APPENDIX D – ENGAGEMENT MATERIAL/ EMAILS/PRESENTATIONS

Subject: Heathrow - Slightly Steeper Approaches Design Principles Update & Q&A

STAKEHOLDERS ASKED, HEATHROW ANSWERED

*SLIGHTLY STEEPER APPROACHES:
ENGAGEMENT ON COMPREHENSIVE LIST OF OPTIONS*

OPTIONS FOR DIFFERENT RNAV APPROACH ANGLES

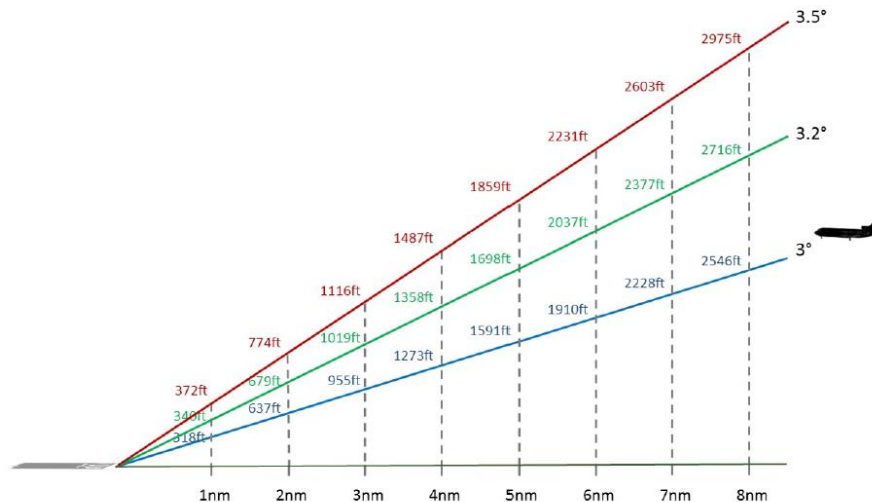
>3.5° Landing on the runway from angles greater than 3.5° is not operationally viable for many aircraft and some may require modifications.

To have a final approach angle steeper than 3.5° at Heathrow would require a 'segmented approach' which is where the steeper angle has to shallow prior to landing. Operators would require training and individual operational approval from the CAA to fly segmented approaches.

Heathrow safely trialled segmented approaches in 2014 for just 6 flights with a minimum final approach spacing of 10nm between arriving pairs. This significant increase in final approach spacing would be detrimental to the existing Heathrow operation.

3.5° Operators expressed concerns over the ability to adhere to the strict speed limits imposed on final approach at Heathrow which could lead to increased risks of go-arounds or increased runway occupancy time. In addition, increased spacing on final approach would be necessary to address the risk of turbulence from following aircraft flying a 3.0° approach.

No data available on the impact of 3.5° approaches on a high intensity operation.

3.2° Heathrow's live trials have provided evidence that this angle provides a small noise reduction (average 0.5db SEL) with no negative operational impact.

EXAMPLE OF A DESIGN ENVELOPE FOR EXPANSION

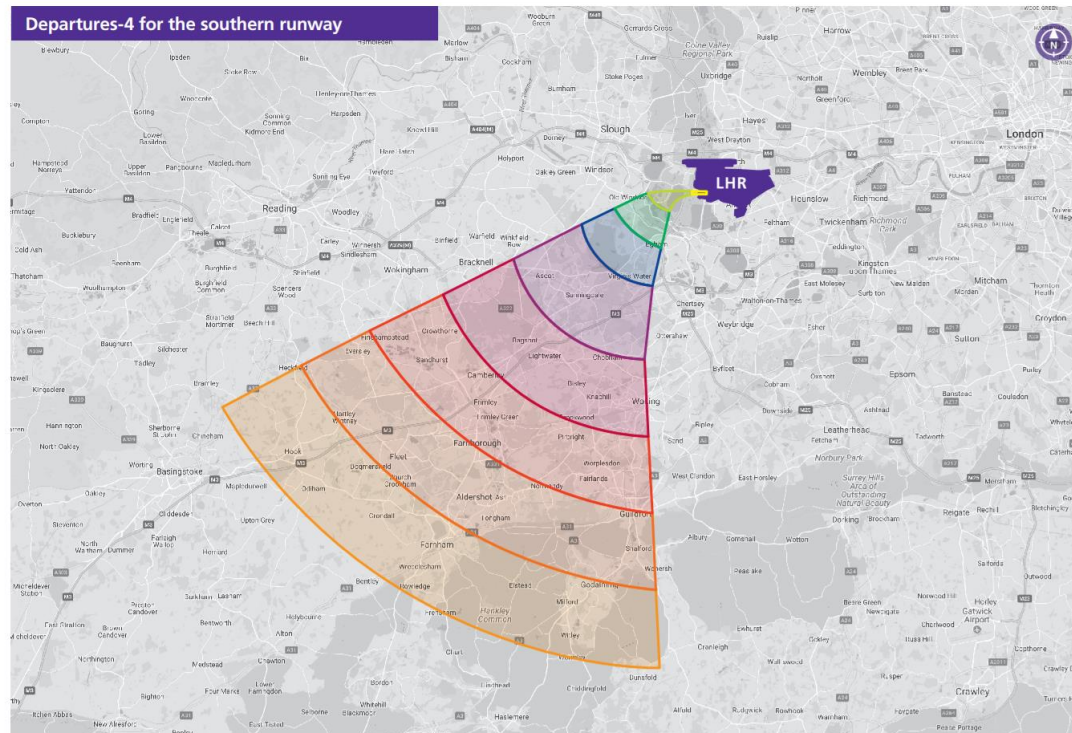
- 15) Comment on design envelopes from Airspace and Future operations Consultation: colour coding is useful. Suggest 2 more categories: for each colour category indicate noise levels + relative noise levels to everyday sounds

- 17) Envelopes looks like it suggests departures of 18000ft – correct?

- This was provided during the consultation; sound booths + noise experts
- 16) Could ■ comment on airspace on being messy because it's based on point-point navigation systems, but in future when trajectories are used, capacity + efficiency could be improved – is this valid?
